MONA OFFSHORE WIND PROJECT

Technical Engagement Plan Appendices Part 1 (A to E)

Document Number: MOCNS-J3303-RPS-10029

February 2024

Figure 1.1 Survey Location

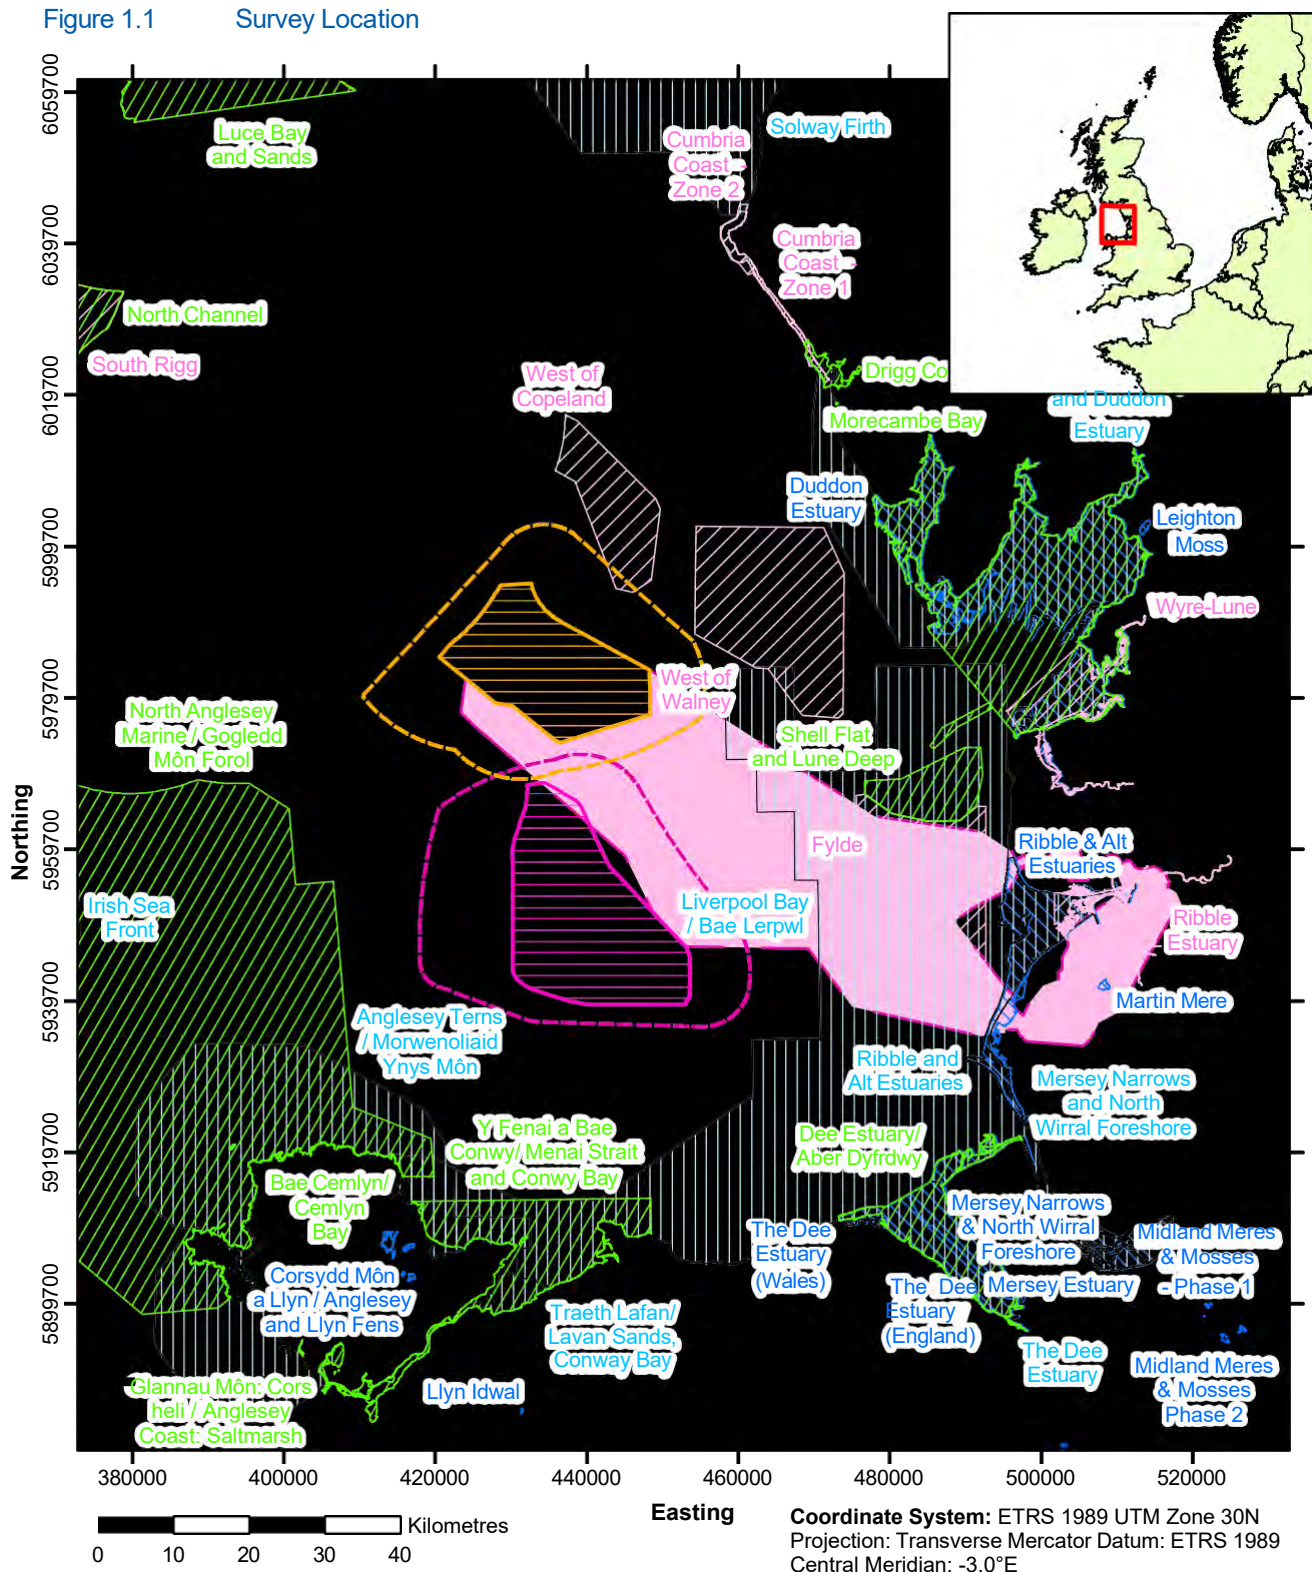
We acknowledge that the Export Cable Route (ECR) presented in *Figure 1.1 Survey Location*, includes a wide scope and that the report sets out that these scoping areas will be more defined and refined

Natural England advise that the presentation of the designated sites and ECR Scoping Areas displayed in *Figure 1.1 Survey Location* needs improvement, as in the current form Fylde Marine Conservation Zone (MCZ) is not visible against the Penwortham ECR Scoping Area. We advise that the map is reviewed and amended.
